ASSESSMENT REPORT

Sydney International Convention, Exhibition and Entertainment Precinct (SICEEP), Darling Square (formally The Haymarket) and the North West Plot, Darling Harbour

SSD 6013 MOD 3

Figure 3: Comparison of approved (left) and proposed (right) ground floor layout. Source: applicant's EIS.

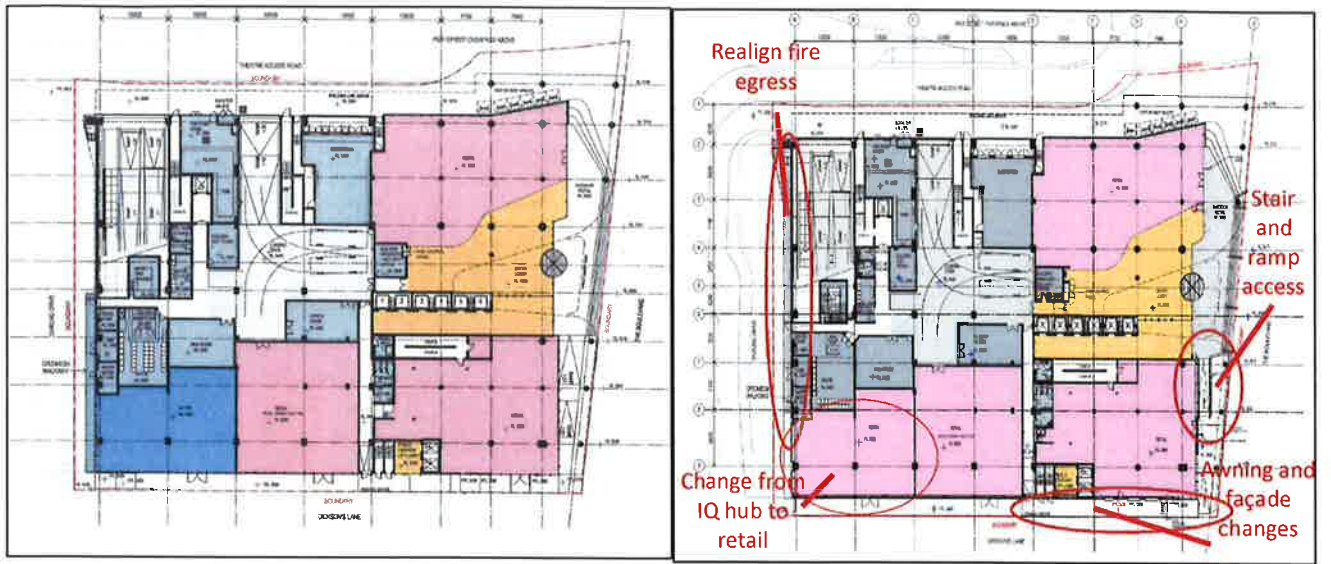
The Department has also considered the visual impacts of the other proposed changes, including the ground level changes, façade amendments, and proposed roof level plant. The Department considers the proposed changes are relatively minor, do not materially alter the appearance of the development, improve the activation at the ground floor level, and would not result in any adverse visual impacts.

Figure 4: Comparison of approved (left) and proposed (right) level 12 outside terrace. Source: applicant's EIS).

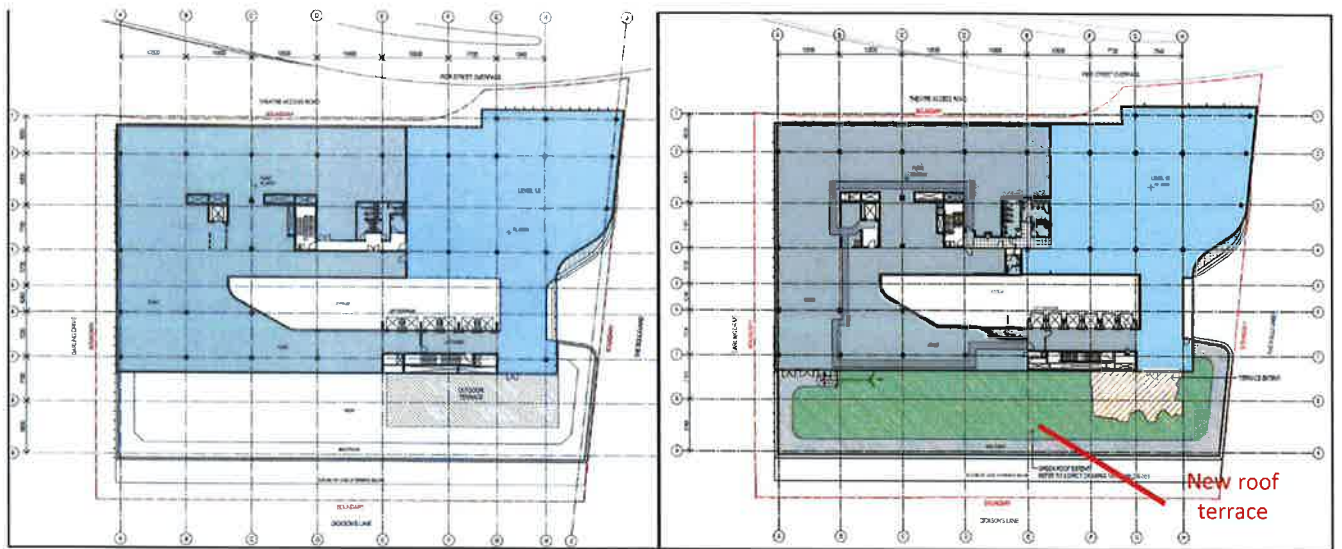
- roof level balustrading, suggesting it be set back to reduce its appearance; and
- the Level 12 terrace landscaping, suggesting it should be provided to a high standard as it would be visible from surrounding buildings and the public domain.

With regard to the terrace area at Level 12, the applicant argues the proposed landscaped deck area will significantly enhance the amenity of this space and provide an improved visual outcome.

Given the location of the terrace at roof level, the Department does not consider it would be highly visible from the public domain. The Department is satisfied the amendment to the Level 12 terrace area provides a high quality landscaped environment which would make a positive contribution to the visual appearance of the site when viewed from the public domain or surrounding buildings.
